Bid Bulletin #01

PROJECT: McCook Municipal Facility
Bid Package #11084-04
505 West C Street
McCook, NE

ADDENDUM NO. 1
(BID PACKAGE FOUR)

McCook MUNICIPAL BUILDING
NEW BUILDING FOR CITY OFFICES, FIRE DEPT. AND POLICE DEPT.
505 WEST C STREET
McCOOK, NE 69001

Sheet:
E1.1a

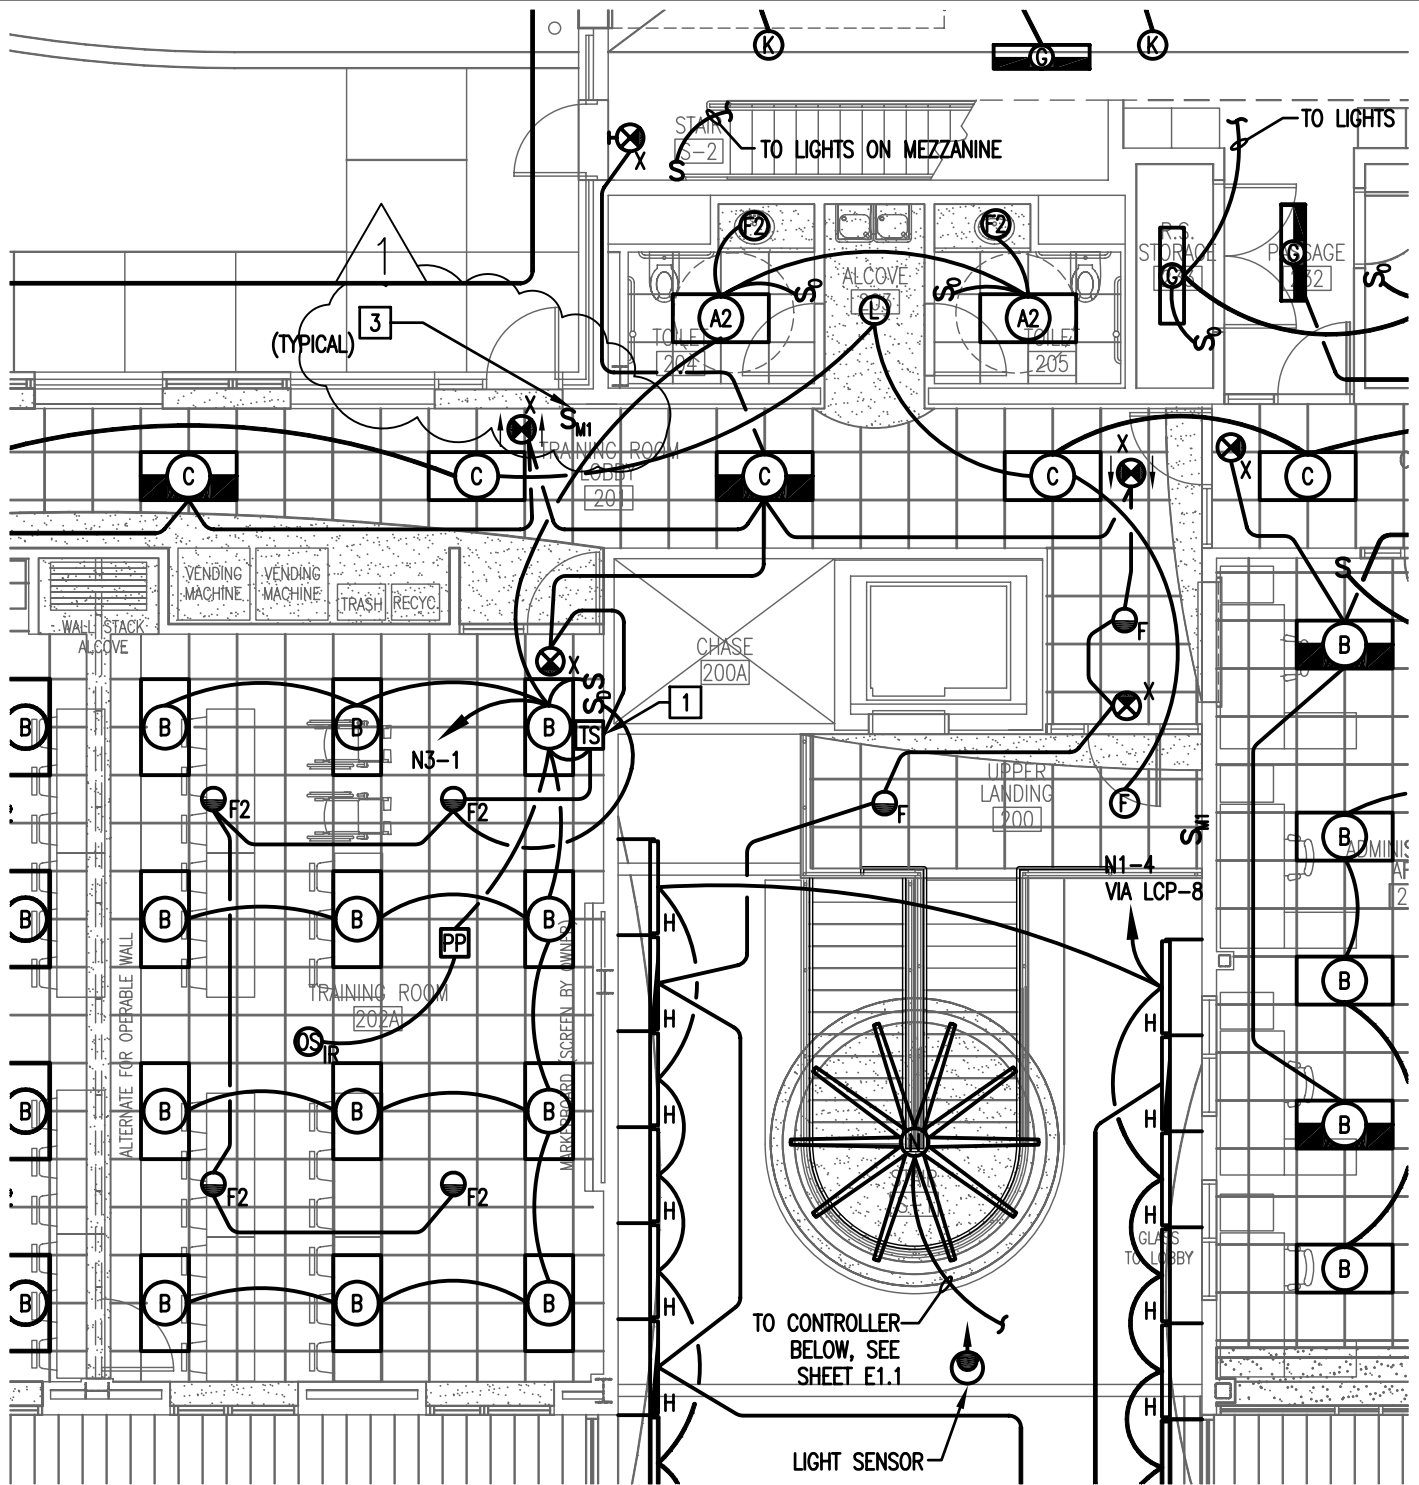
- a. Refer to Sheet Notes (upper right-hand corner). Add Keynote #4 to state: “#4. Momentary Switch for Timeclock override.”

- b. Refer to FIRST FLOOR LIGHTING PLAN. Add notation for momentary switch, three places on plan, per attached SUPPLEMENTAL DRAWING #E1.1a, included with this addendum.

4 MOMENTARY SWITCH FOR TIMECLOCK OVERRIDE.
